**Queensland Coal Mining Board of Inquiry
Re: Question for Dr Bharath Belle - Fan Pressures Diagram**

We refer to your letter dated 15 April 2021 requesting answers from Dr Bharath Belle to two questions in relation to fan pressure (**Questions**). The below response is provided directly by Anglo, although Dr Belle has been consulted as part of the preparation of the response.

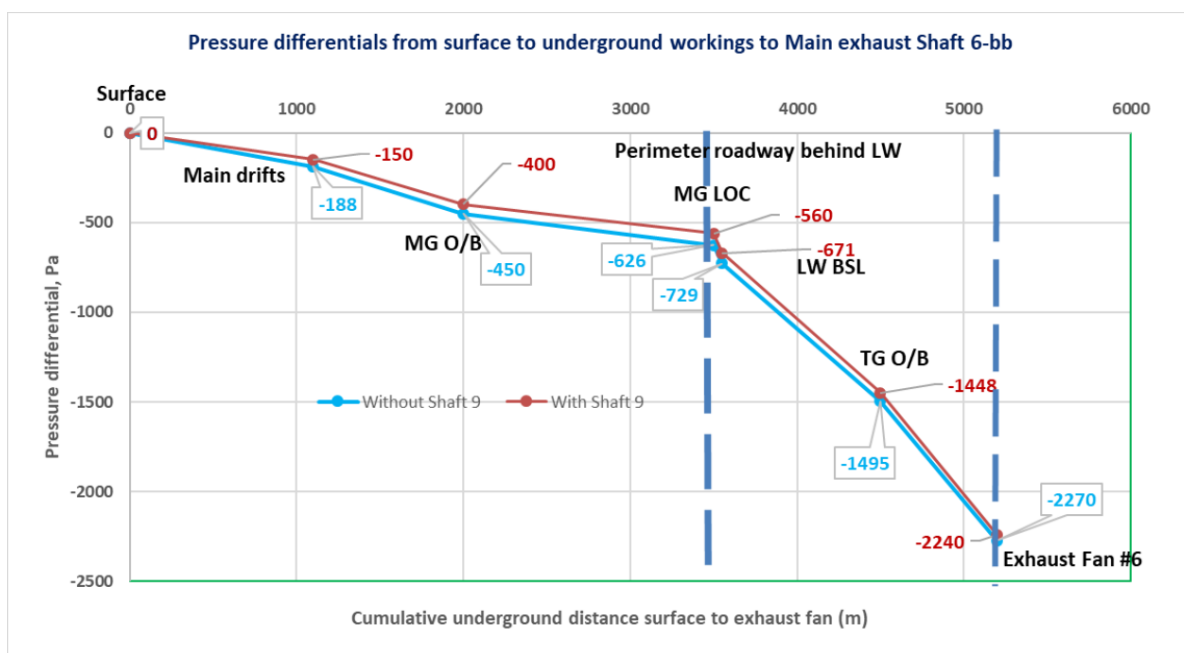
- (d) The diagram provided in Question 2 is not correct, for the following reasons:
 - (i) The internal BAC fans are incapable of producing the airflow or pressure used in the diagram;

- (ii) The No. 9 Shaft is not capped (and, in fact, if it were, there would be no airflow through the shaft and correspondingly no static pressure measurement); and
- (iii) The No. 9 Shaft is a relatively minor part of the ventilation system which has a negligible effect on the main exhaust fan at No. 6 Shaft. This can be seen from the following graph, which plots the typical pressure drop between the surface and the No. 6 Shaft exhaust fan both with and without the contribution of the No. 9 Shaft.
